FINAL EIR/EIS FOR THE MASTER SPECIAL USE PERMIT AND PERMIT TO CONSTRUCT POWER LINE REPLACEMENT PROJECTS

Volume II: Response to Comment Letters

1. INTRODUCTION TO VOLUME 2, RESPONSES TO COMMENTS

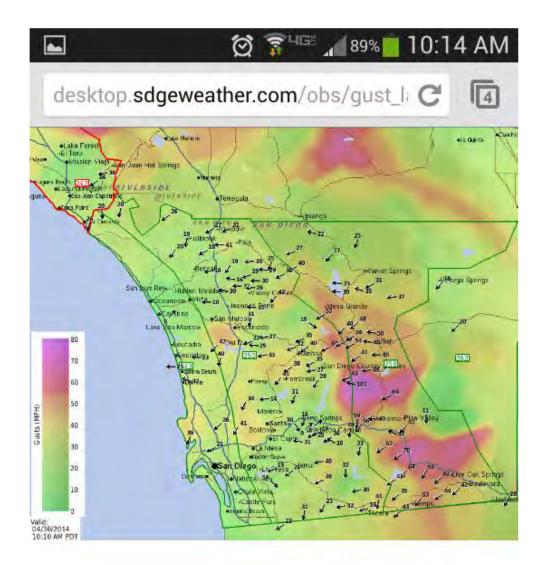
Please include this image and update all my comments regarding

Maximum wind speed on TL626 and D79 in the CNF master permit process. Maximum recorded wind speed on TL626/D79 is now 101 mph.

F11-25

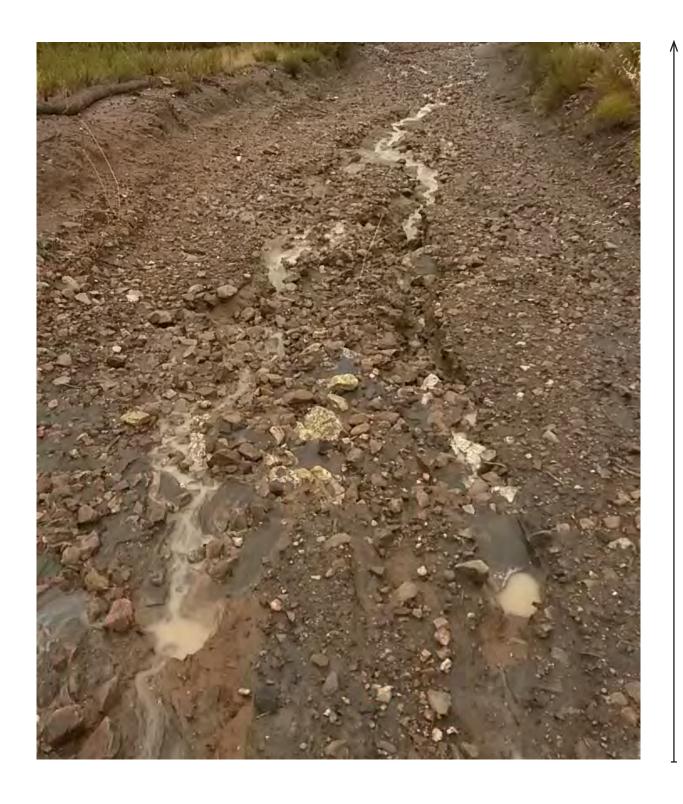
Same road section as shown in previous photo erosion comments. Please include this comment with those photo comments showing measurement of this road section.

Photo shows 22% percent grade on TL626/D79 access road during summer thunderstorm. Note water running down road and causing erosion issues. Road was maintained under BMP by SDG&E last year. Under current proposed master permit, this road section would meet standards. Every year this section would have to be graded to restore. The 25% grade limit is not acceptable. Please modify the master permit from 25% max grade to at least 20% max allowable grade.

- F11-6 The comment and supporting images of slope steepness and erosion on steep access roads are noted. The 25% terrain gradient was used in the analysis to identify those areas that were likely to have problems that could not be corrected due to excessive road gradient, and is not necessarily an absolute limit. As described in the EIR/EIS, road segments greater than 15% were addressed through implementation of MM HYD-4. Figures B-3 through B-7 included in the Final EIR/EIS, depict SDG&E exclusive-use access roads and those proposed by SDG&E to be removed as part of the proposed project; and Figure C-1A depicts those roads recommended for removal under the Partial Removal of Overland Access Roads Alternative. MM HYD-4 has been modified in response to comment F11-5 to include road closures as part of the evaluation process, which will expand the potential solutions to include road closure for segments that cannot be stabilized through implementation of best management practices (BMPs).
